MFN 06-498

Subject: **Response to Portion of NRC Request for Additional Information  
Letter No. 53 Related to ESBWR Design Certification Application –  
DCD Chapter 4 - RAI Number 4.4-20**

**Partial Response to RAI Letter No. 53 Related to ESBWR**

**RAI Number 4.4-20**

**Figure 3.9-5 Pressure Nodes for Reactor Internal Pressure Difference Analysis**

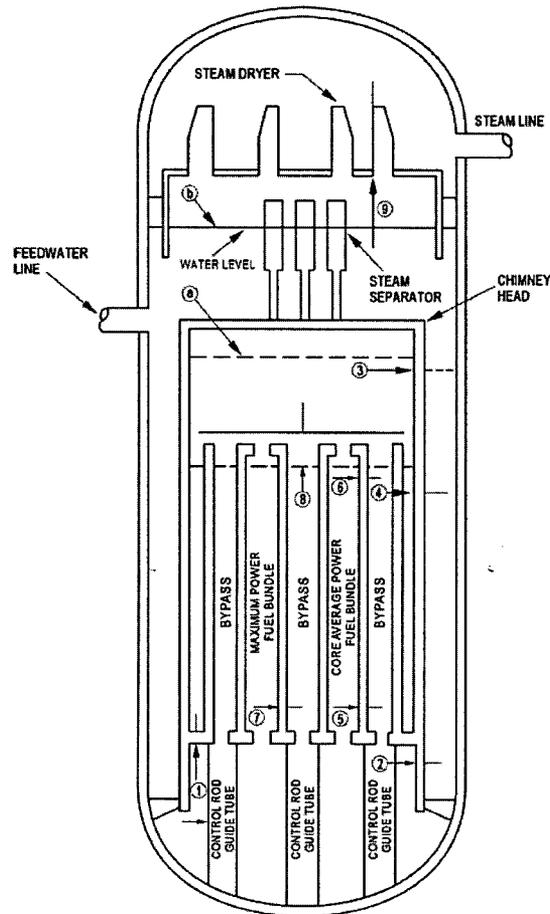
*DCD Tier 2, Sections 4.4.1.3, 4.4.2.3, and 4.4.3.3 discuss the bases, methods, and evaluation of the core pressure drop and hydraulic loads but do not provide sufficient detail for staff review. Provide a discussion of the calculation of the reactor internals pressure drop and associated loads for normal and transient operation, including the model, input data, assumptions, and results. Discuss the applicability of the referenced TRACG topical report to the ESBWR design.*

GE will correct a typo (replace “Figure 5.3-2” with “Figure 5.3-3” in the DCD Tier 2 Subsection 3.9.5) and revise Figure 3.9-5 as shown below to resemble the ESBWR.
